# Technical Service Bulletin

SUBJECT:			No: <b>TSB-16-51-003</b>
<b>TAILGATE GARNISH CONTACTING REAR COMBINATION LAMPS</b>			DATE: <b>November, 2016</b>
			MODEL: <b>2014-15 Outlander</b>
CIRCULATE TO:	<input type="checkbox"/> GENERAL MANAGER	<input checked="" type="checkbox"/> PARTS MANAGER	<input checked="" type="checkbox"/> TECHNICIAN
<input checked="" type="checkbox"/> SERVICE ADVISOR	<input checked="" type="checkbox"/> SERVICE MANAGER	<input checked="" type="checkbox"/> WARRANTY PROCESSOR	<input type="checkbox"/> SALES MANAGER

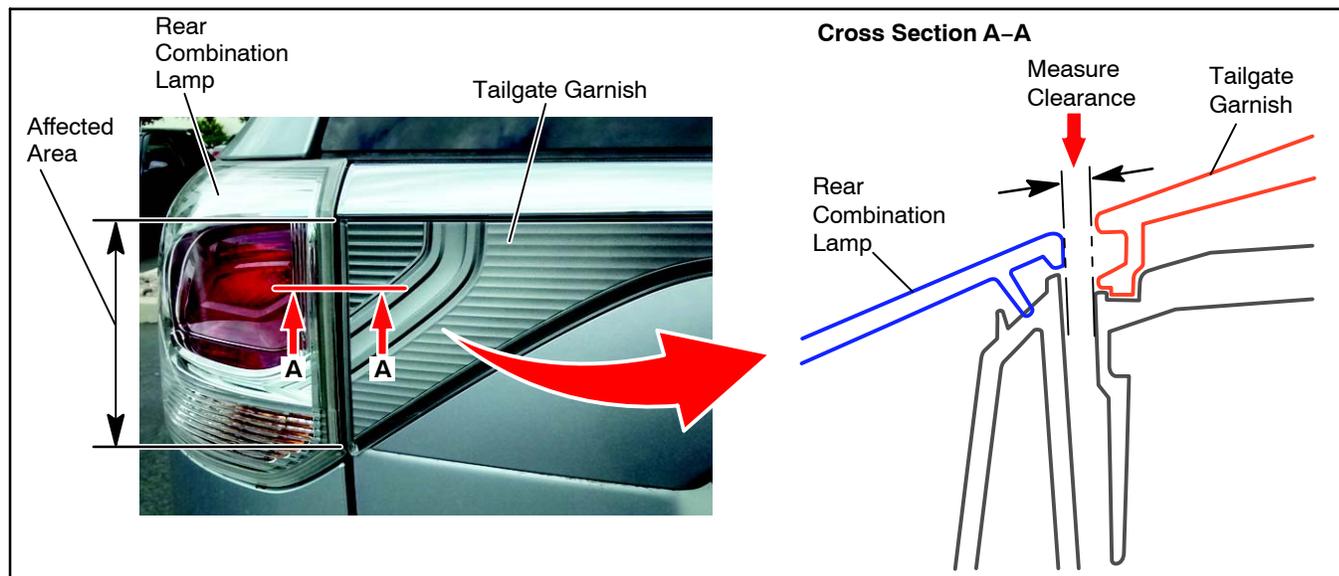
In some vehicles, there is a possibility of the tailgate garnish contacting the rear combination lamps. This may be due to insufficient clearance between the tailgate garnish and the rear combination lamps. Dimensions between the parts may also change due to heat expansion and normal usage. This TSB instructs dealers to replace the tailgate garnish in affected vehicles, how to measure the proper clearance between the tailgate garnish and rear combination lamps, and adjust if necessary.

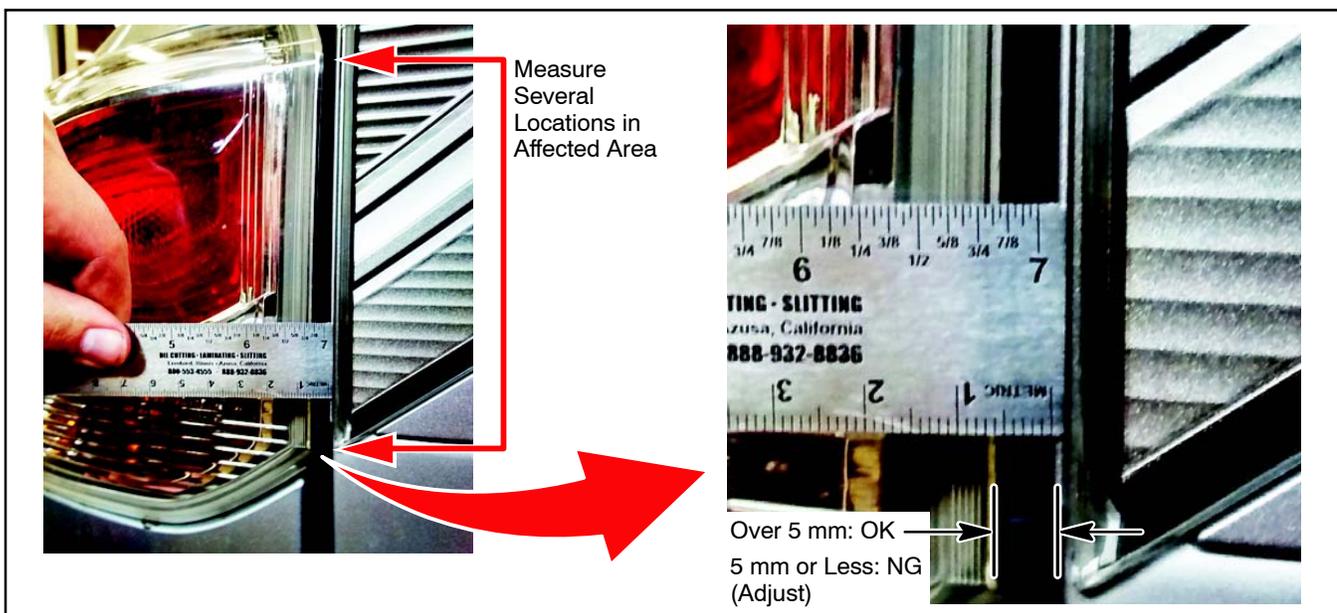
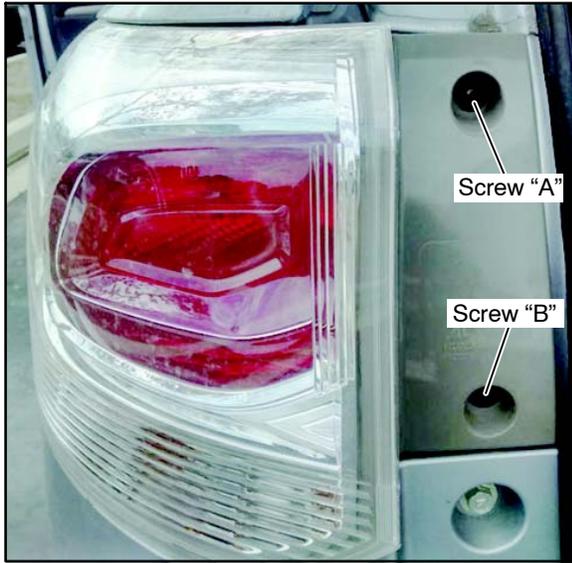
1. In vehicles where the tailgate garnish is contacting the rear combination lamps as a result of this concern, replace the tailgate garnish with the countermeasure part, following instructions in the Service Manual, Group 51-Exterior -> Liftgate Garnish -> Removal and Installation.
2. Measure the clearance between the tailgate garnish and rear combination lamp in the affected area shown below.

- a. Open the tailgate and hold slightly away from car until the body-colored side panel of the tailgate garnish is visible.

- b. Measure the clearance between the side panel of the tailgate garnish and rear combination lamps in several places along the affected area.
  - If clearance is 5 mm or LESS, go to step 3 to perform adjustment.
  - If clearance is more than 5 mm, no adjustment is needed.

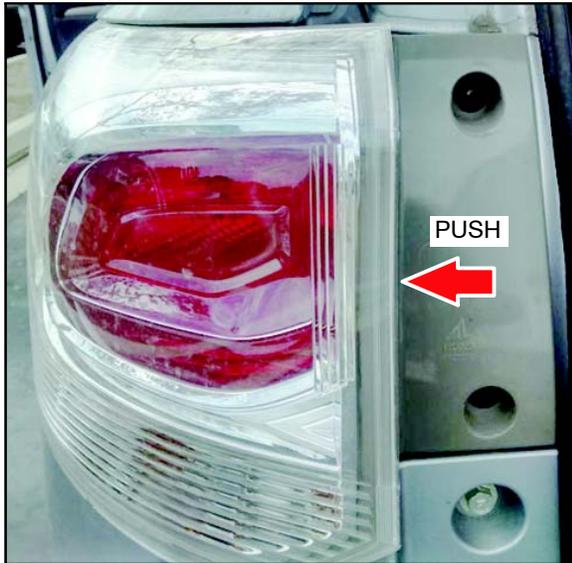
a. Open the tailgate, and loosen screws "A" and "B."

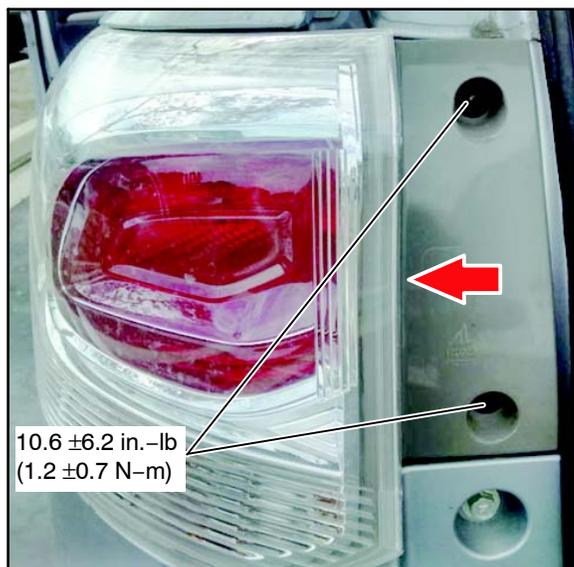
b. Push the rear combination lamp to the outside by hand until the clearance between the tailgate garnish and rear combination lamp is more than 5 mm.

- c. Tighten the screws while keeping the rear combination lamp in this position.
  - d. If necessary, repeat the adjustment on the other side.
4. Measure the clearance again between the tailgate garnish and rear combination lamps, as described in step 2, and confirm it is more than 5 mm.
